S.A.T.	285 MV
area	n°

Service Bulletin

Subject: **Lambda probe plug**

Product: **B4 1000 EURO 5 RR – RS – RUSH**
from VIN: ...NV000011 to VIN: ...NV000249 included, plus VIN ...NV000270

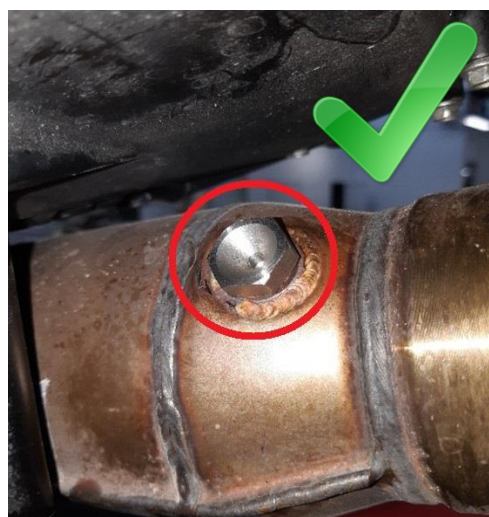
- Remove the protection of the exhaust manifold on the LEFT side by acting on the 5 fixing screws with a 4mm Allen key:

- Locate and remove the plug of the lambda sensor with a hexagonal key:
- **NOTE: The removed plug MUST NOT BE USED AGAIN.**

- Take the new plug cod. **8000D0759** and apply it to the Lambda probe socket using a 17 mm hexagon socket insert, tightening it to a torque of **40 Nm**.

NOTE: The probe plug does not require a washer, lubricant or thread locker.

- Refit the protection of the LEFT exhaust manifold by acting on the 5 fixing screws with a 4mm Allen key and applying a tightening torque of **10Nm**.
